PIC32MX534/564/664/764 Family Silicon Errata and Data Sheet Clarification

The PIC32MX534/564/664/764 family devices that you have received conform functionally to the current Device Data Sheet (DS61156F), except for the anomalies described in this document.

FIGURE 1: EXTERNAL COMPARATOR SCHEMATIC EXAMPLE

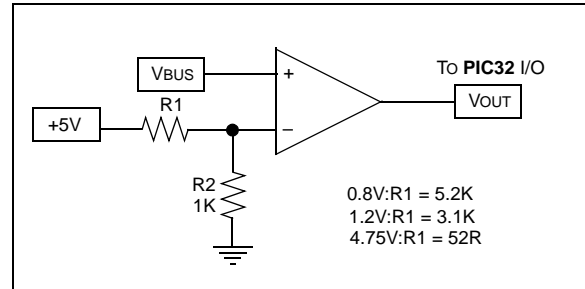
16. Module: USB

When the USB model is configured for OTG operation, it may not properly recognize all required OTG voltage levels on VBUS pin.

Work around

Use external comparator circuit to detect OTG specific voltage levels on VBUS pin.
